ADDENDUM NO.: THREE

REFERENCE:	IFB No:	2025-IFB-1007262
	Dated:	October 8, 2024
	Commodity:	New Construction High School Center II
	IFB Closing On:	November 7, 2024, at 2 PM

ADDENDUM 03

PROJECT: New Construction High School Center II
Albemarle County Public Schools
IFB #2025-IFB-1007262
QE Project No: 41911390

L3 BRICK RUNNEL
L303 SCALE 3/4" = 1'-0"

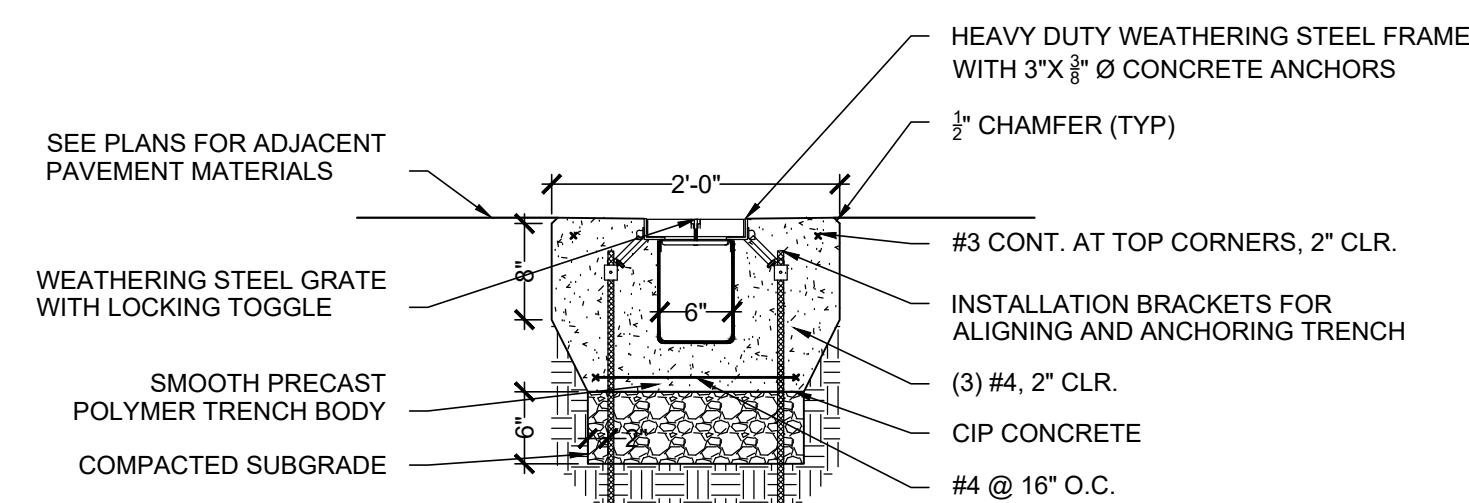
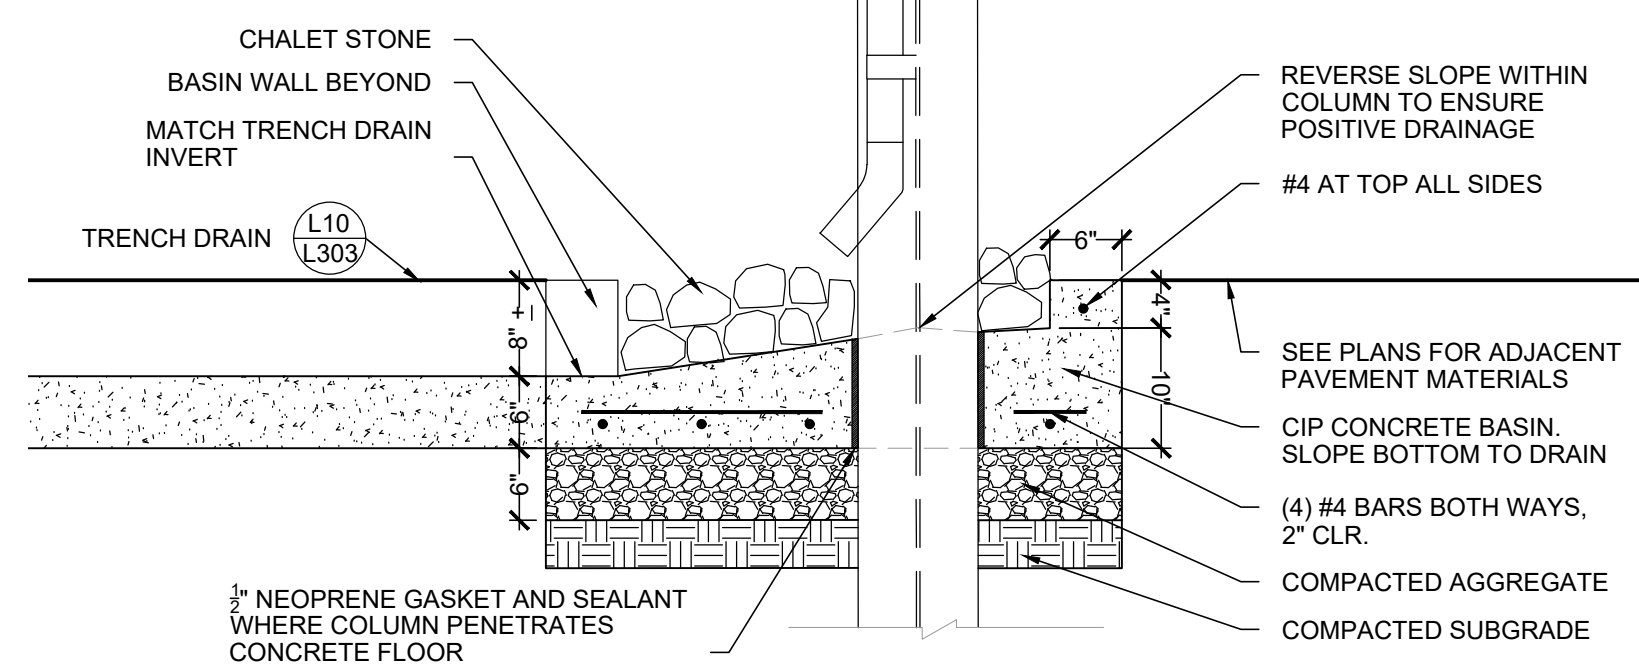
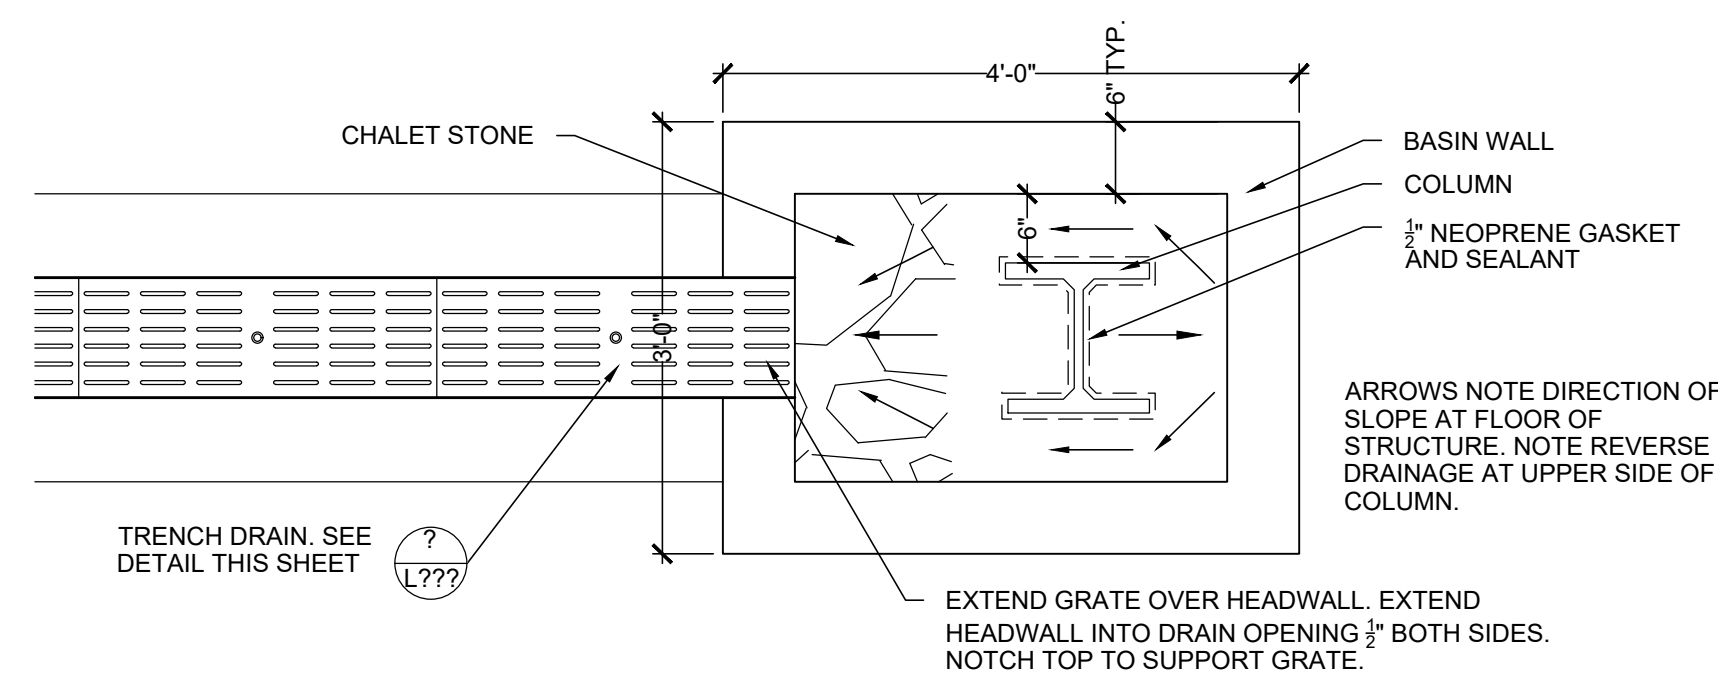
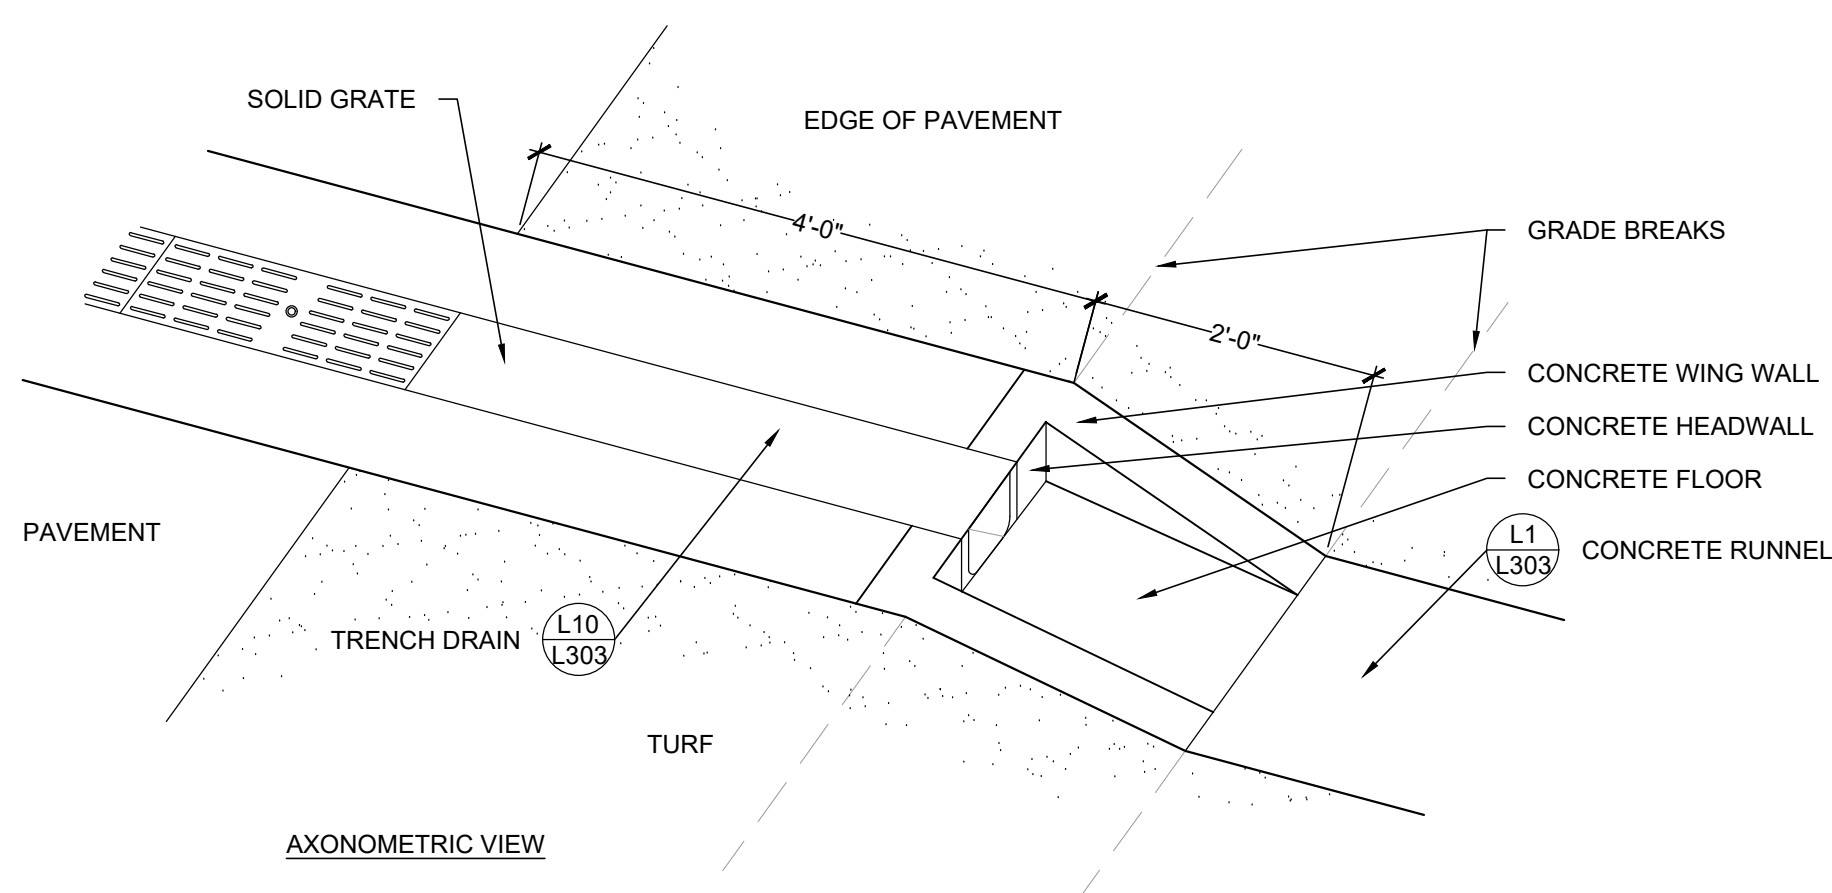
Sheet: L303 – Landscape Details
Replace: With revised Sheet included herein
Changes: Clarifications to Concrete Runnel dimensions and sizes

11 INCOMING SERVICE & DWH SYSTEM DETAIL
SCALE: NONE

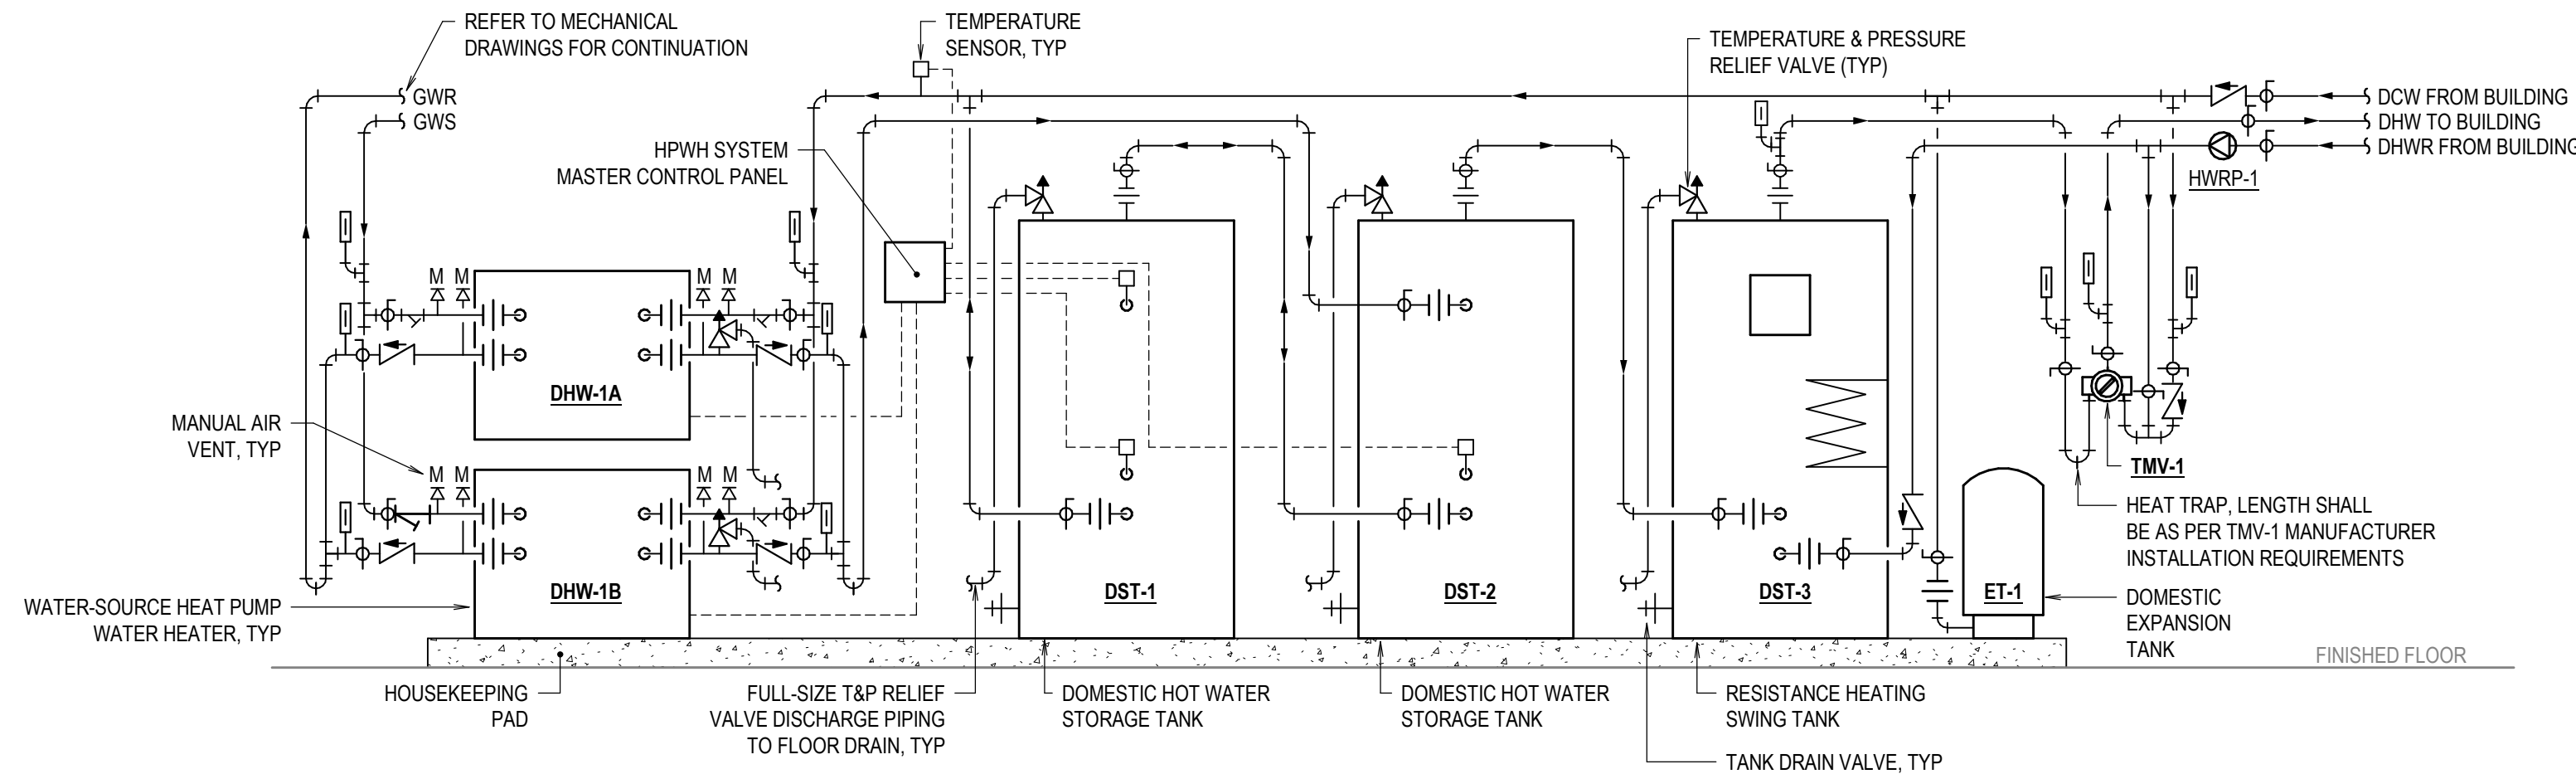
Changes: Add Detail 13/P501 for HVAC MAKEUP CONNECTION DETAIL.
Change PRV to PRV-1 in Detail 11/P501.

2
EP101B | E402
ENLARGED PLAN: ELEC 135 - POWER
SCALE: 1/4" = 1'-0"

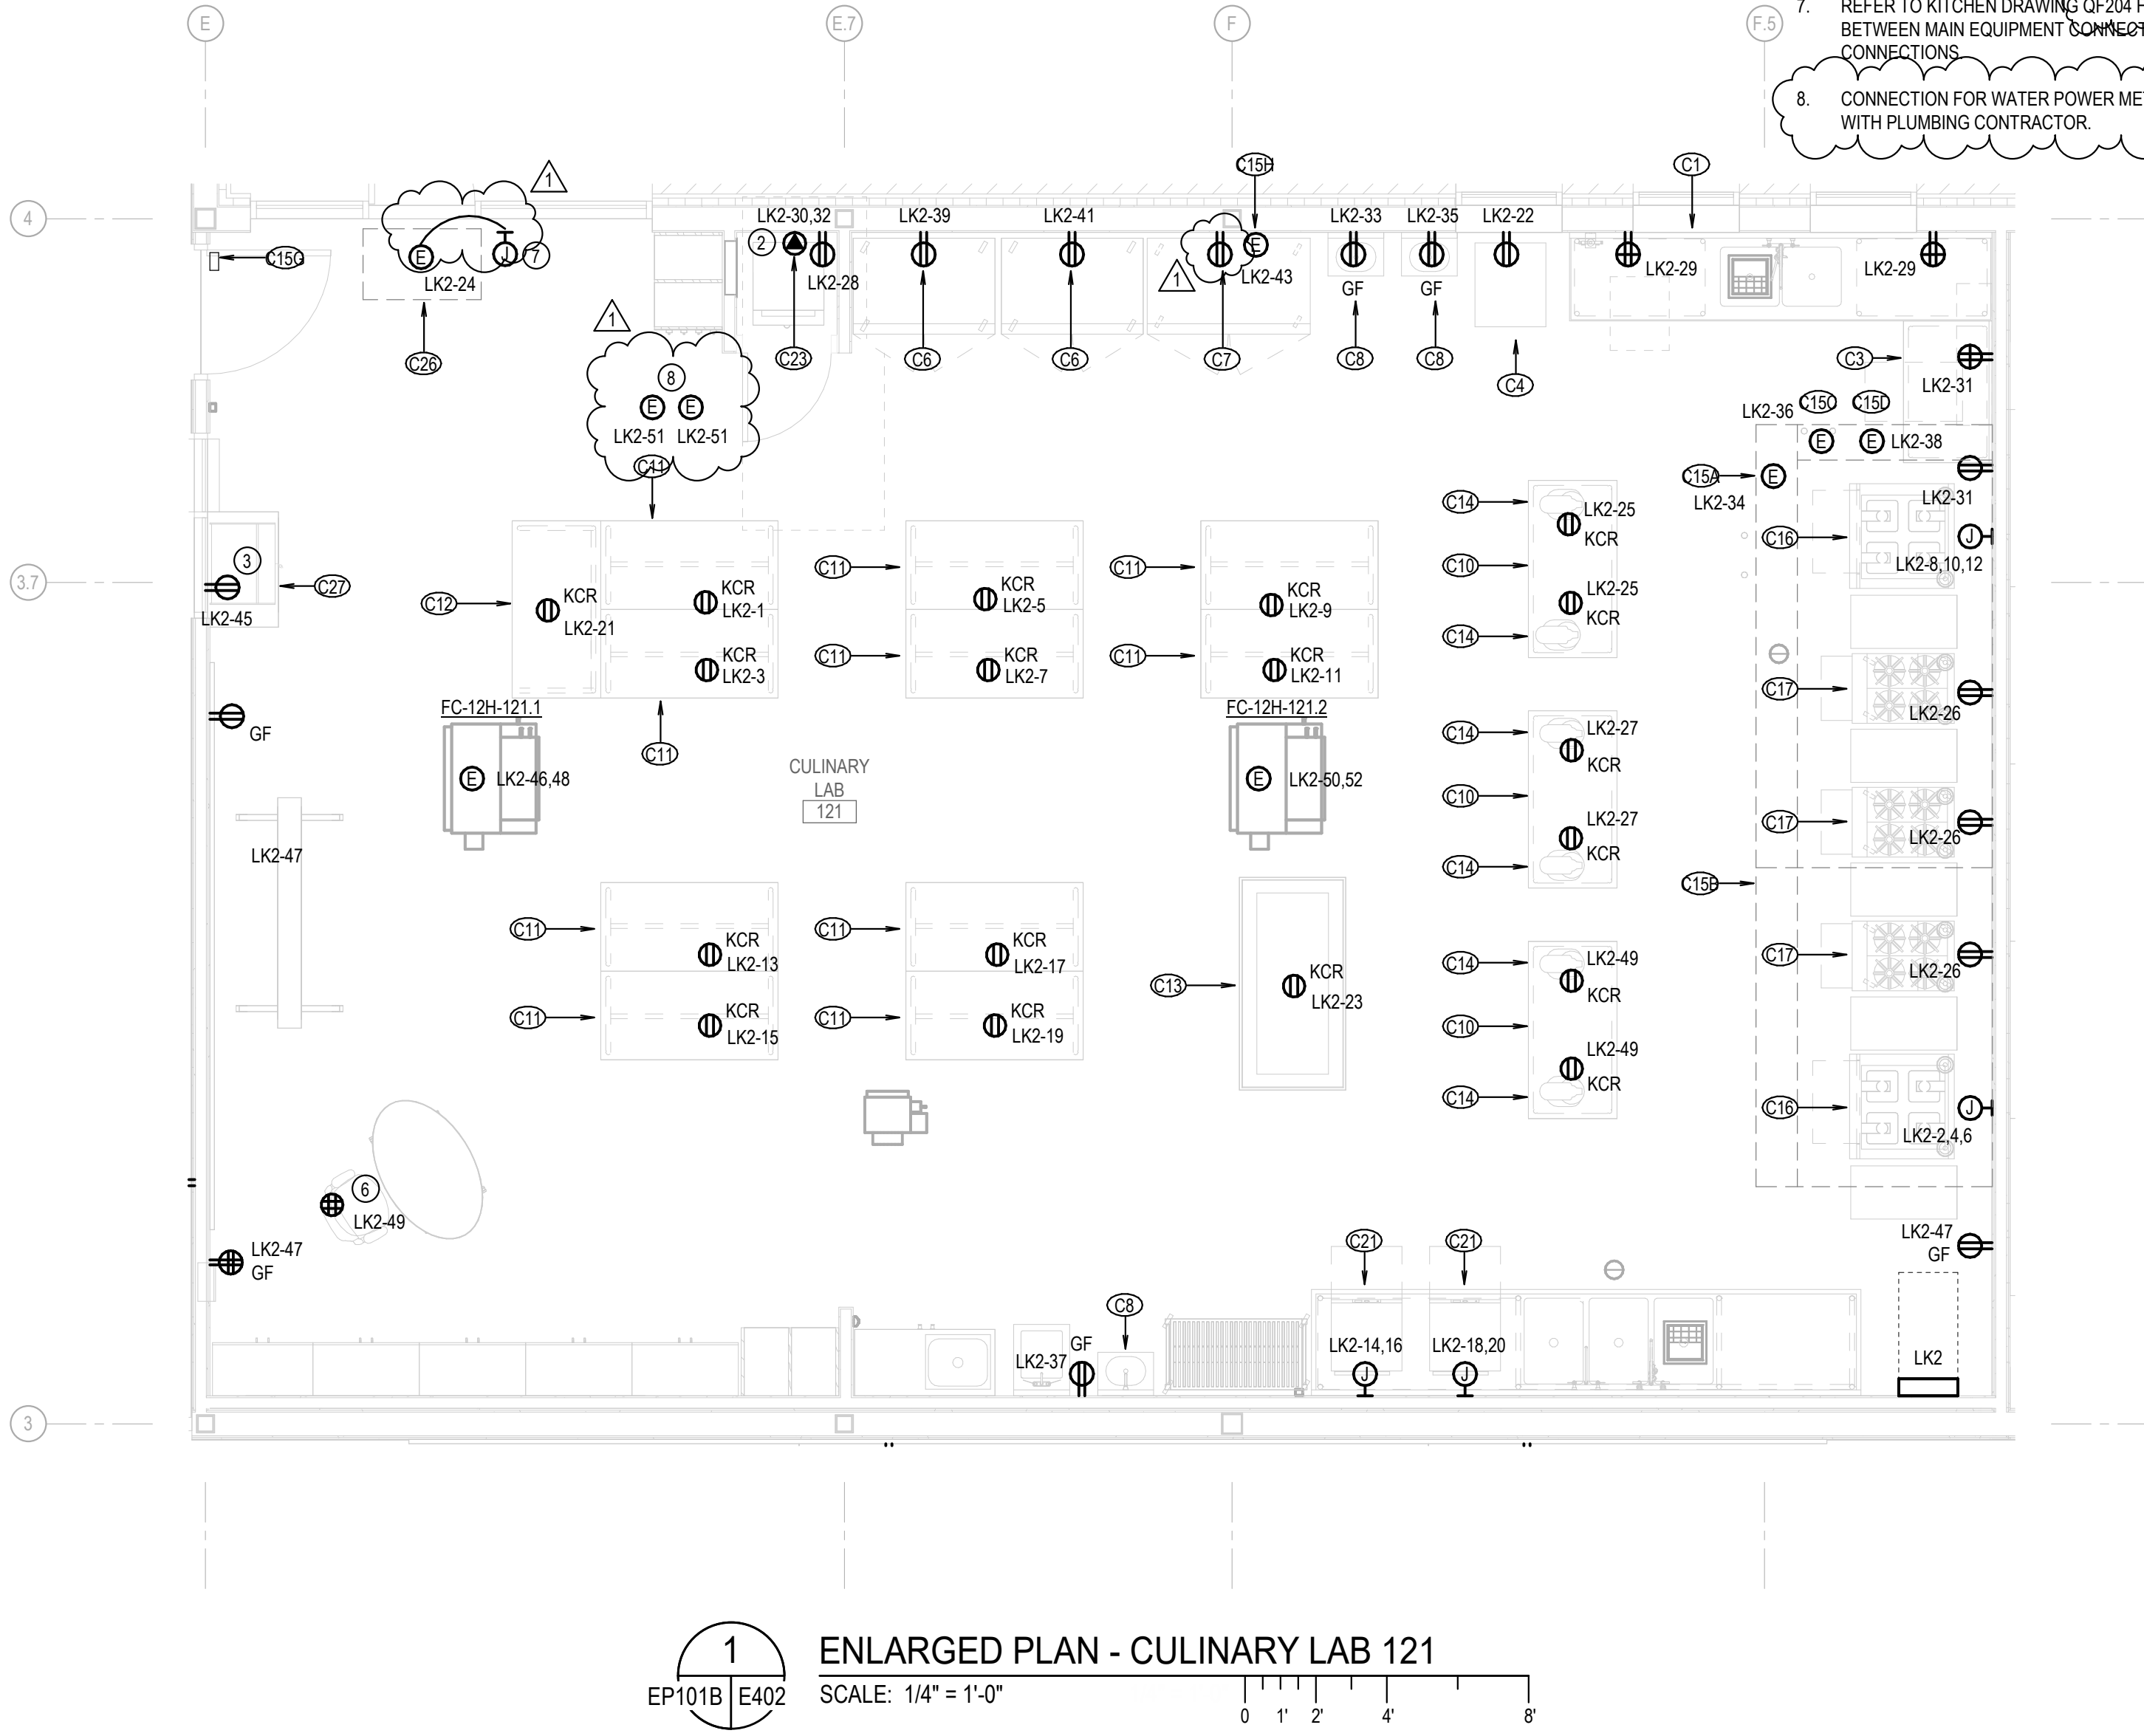
Sheet: E402 – Enlarged Plans
Replace: With revised Sheet included herein
Changes: Revise notes, keynotes, schedules, circuits and devices,
